Committee Report On The RHIC Personnel Safety System at Brookhaven National Laboratory

March 7-9, 1995

SUBJECT: Implementation of recommendations from the External Review of the RHIC Safety System

Subject Recommended actions to the Committee Report On the
RHIC Personnel Safety System at Brookhaven National Laboratory
(March 7, 8 and 9, 1995)

CRITICAL DEVICE COMMUNICATIONS

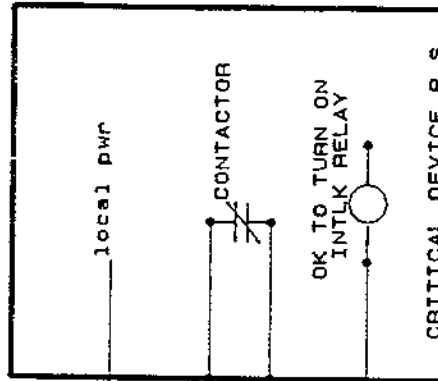
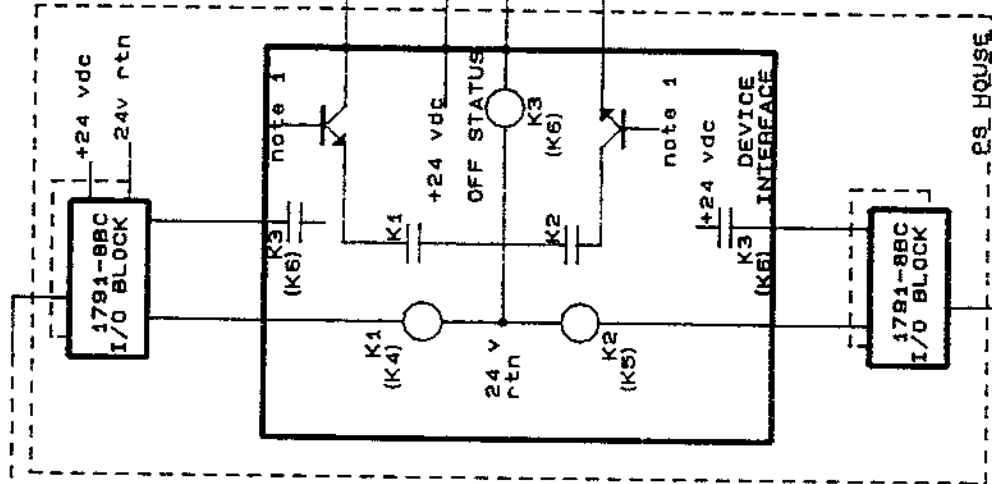
11. The committee recommends additional diversity be employed in the control of the critical device power supplies. It would be possible for one loop to remove the firing pulses to the power supply while the other opens the contactor. It is understood by the committee that the "Reachback" system would ensure the device functioned as commanded. This could be ensured by watching the voltage & current output of the power supply.

In item number eleven the committee was again attempting to stress the separation of the two "loops" or redundant paths. In one of the slides the committee was shown a drawing called "IOBLOCK" "Critical Device Communications" in which the two PLC systems are depicted interacting with one device in the Critical Device Power Supply. The committee is advocating an approach in which two different means of controlling the device are used and the shutdown functions controlled by the 1791-BBC's are completely separated.
